## Staff Report Z-42-23-7

October 13, 2023

Laveen Village Planning Committee Meeting Date:	October 16, 2023
Planning Commission Hearing Date:	November 2, 2023
Request From:	<u>CP/GCP</u> (Commerce Park/General Commerce Park Option) (36.85 acres)
Request To:	<u>C-2 HGT/WVR DNS/WVR</u> (Intermediate Commercial, Height Waiver, Density Waiver) (21.75 acres) and <u>C-2</u> (Intermediate Commercial) (15.10 acres)
Proposal:	Multifamily residential (north) and public school (south)
Location:	Approximately 1,700 feet south of the southeast corner of 63rd Avenue and Baseline Road
Owner:	Laveen Baseline, LLC
Applicant/Representative:	Wendy Riddell, Berry Riddell, LLC
Staff Recommendation	Approval, subject to stipulations

Conceptual Renderings BMA Architecture and Kitchell

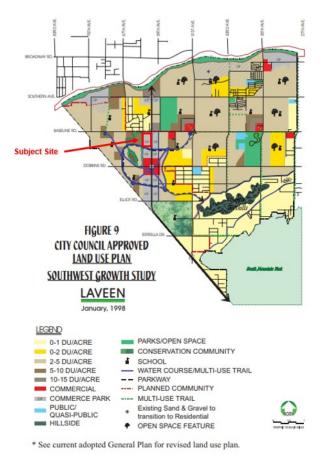
The conceptual building elevations, attached as an exhibit, depict three-story residential buildings with a maximum height of 40 feet. The residential building elevations depict modern farmhouse architecture with pitched roofs, overhangs, and accent materials. The elevations also have accent materials that include brick veneer, vertical siding, metal railing, and window shutters. Staff recommends general conformance to the submitted elevations to ensure the modern farmhouse architectural elements are provided. This is addressed in Stipulation No. 1.

- 1. The multifamily development shall be in general conformance with the elevations date stamped July 10, 2023, as modified by the following stipulations and approved by the Planning and Development Department.
- 2. Residential development shall comply with R-4 PRD development standards.
- 3. A minimum 60-foot building setback shall be provided along the west perimeter of the site.
